Review Comments

Project: Brighton Recovery Campus-Building D
Project No: 20160686

From: Jason Worthen
Date: April 12, 2017

BUILDING D RESPONSES

EL601

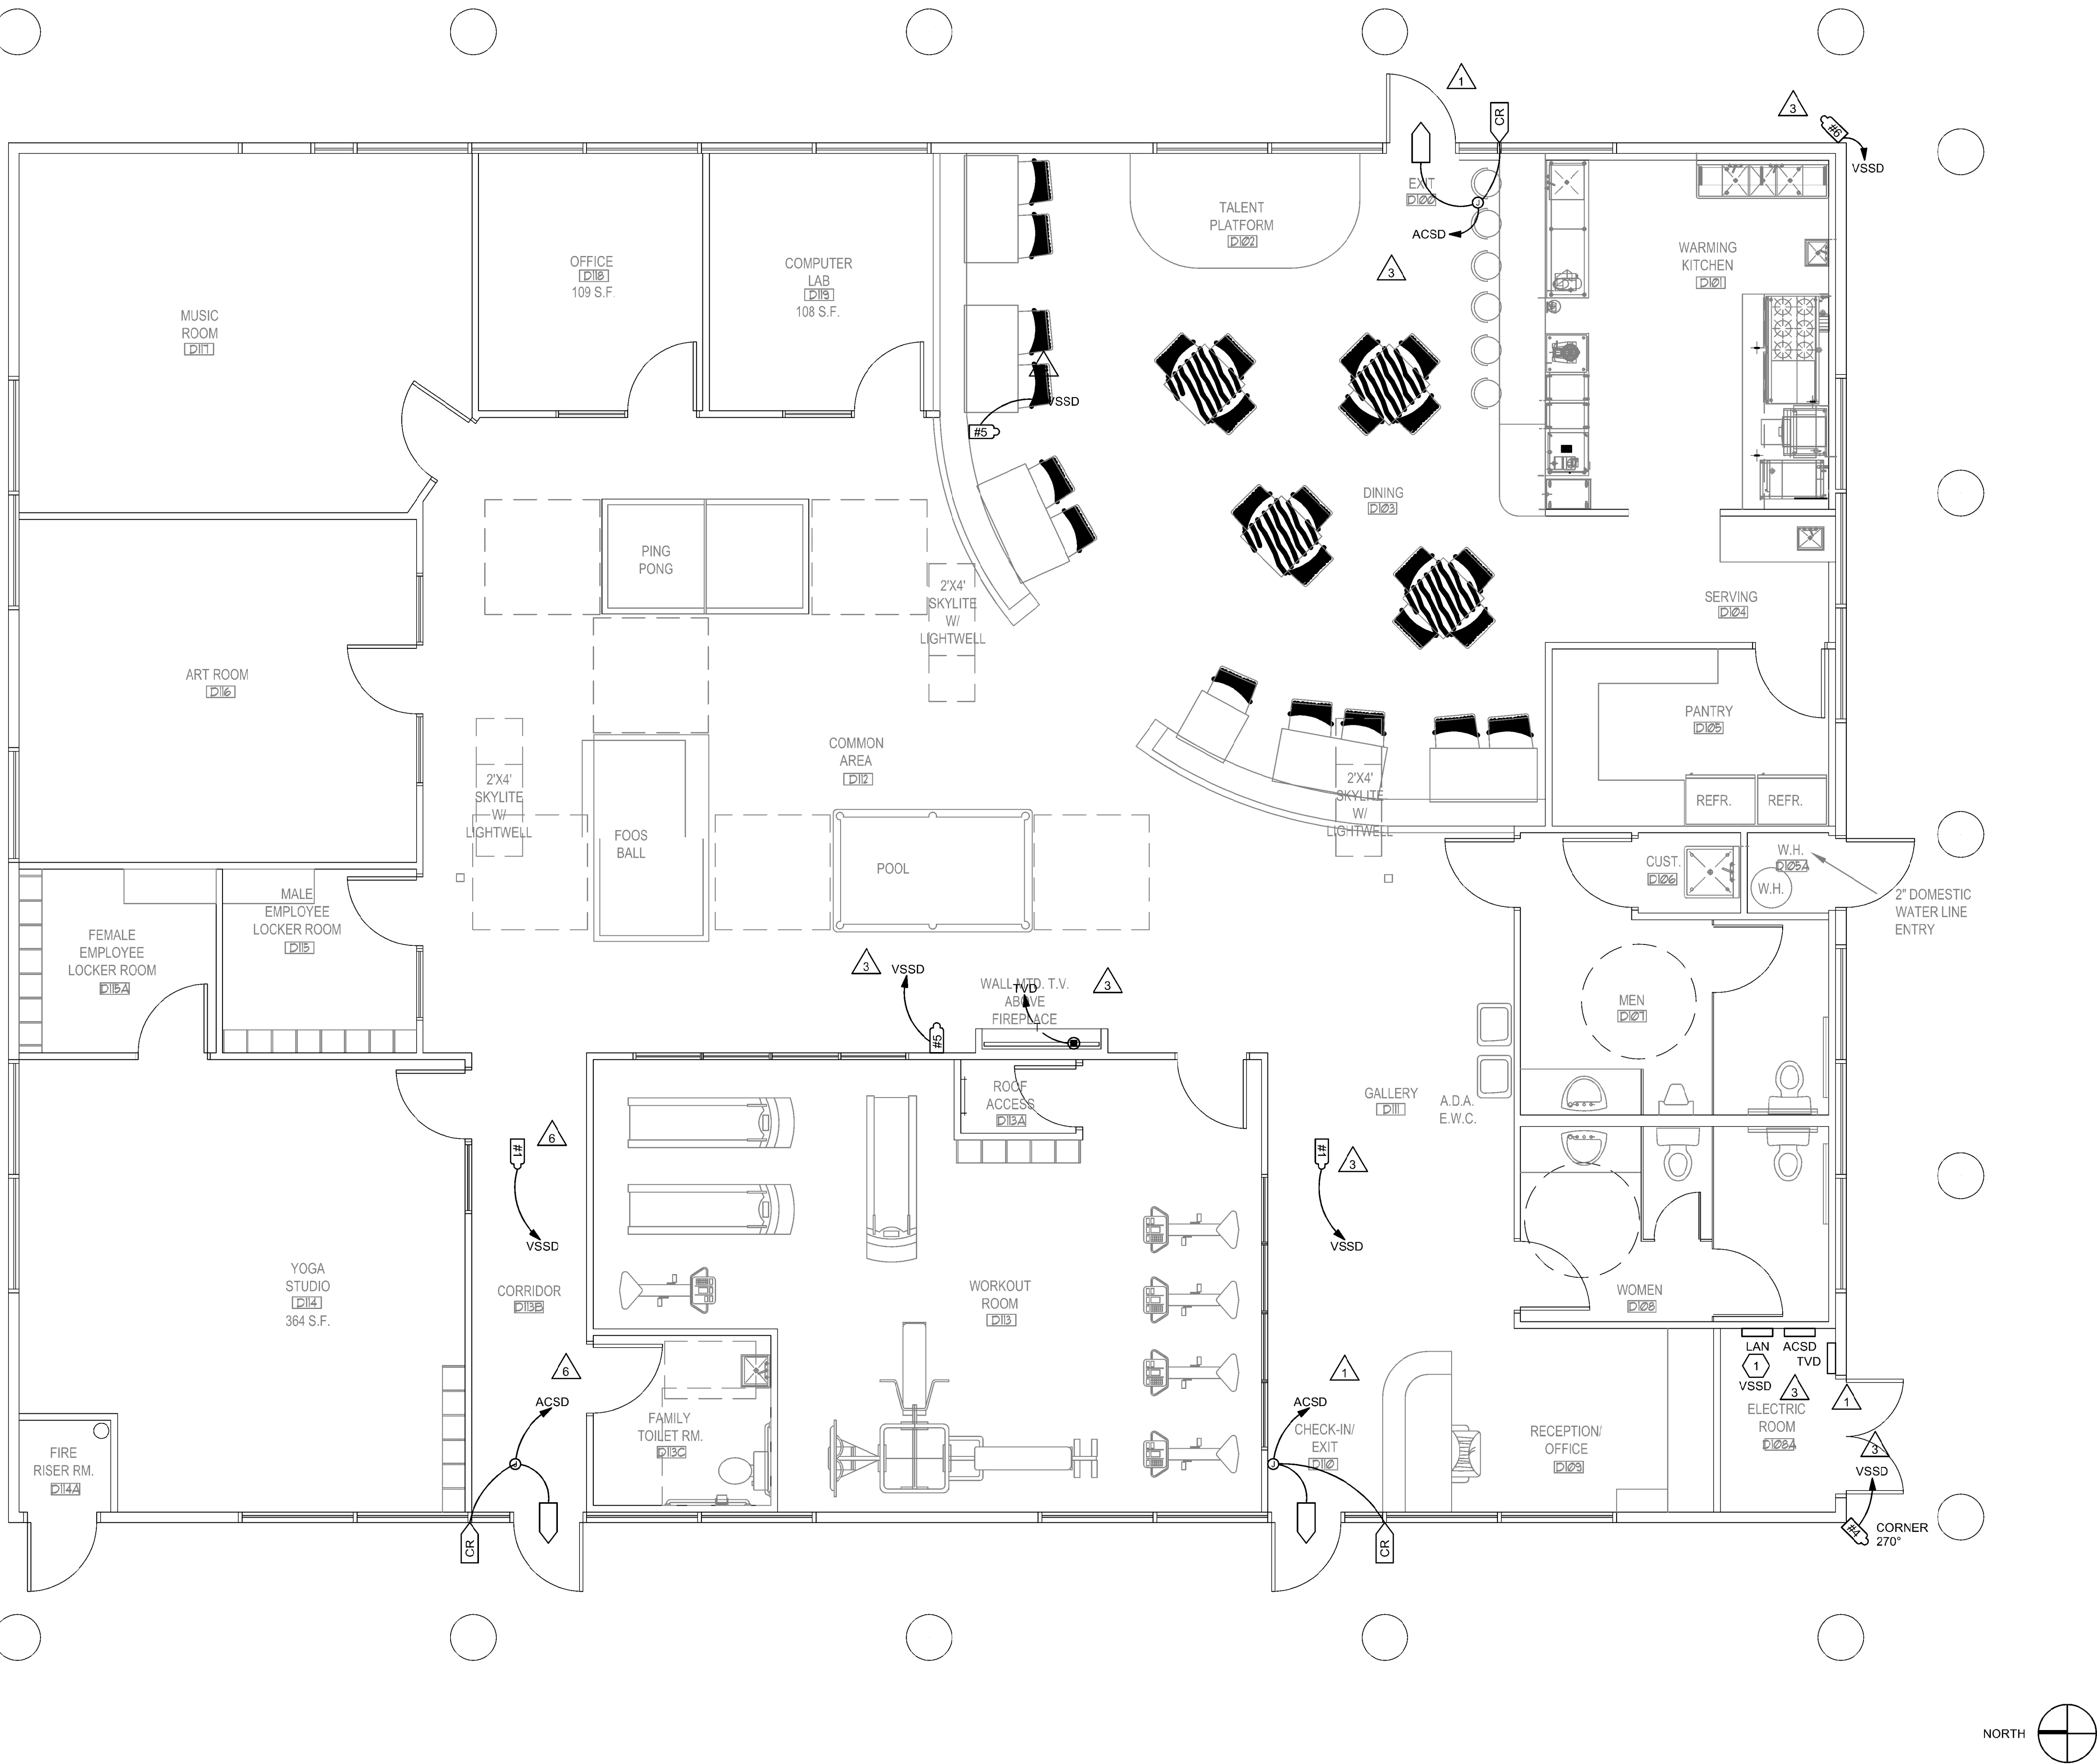
N2. Sheet EL601: Recessed lighting shall be IC rated and airtight if penetrating the air or thermal barriers per IECC C402.5.8.

EL601 (see attached sheet)

1. Changed the acceptable fixture types for DX-1, DX-2 and DX-4 fixtures.

Response: Modified all can lights to be IC rated.
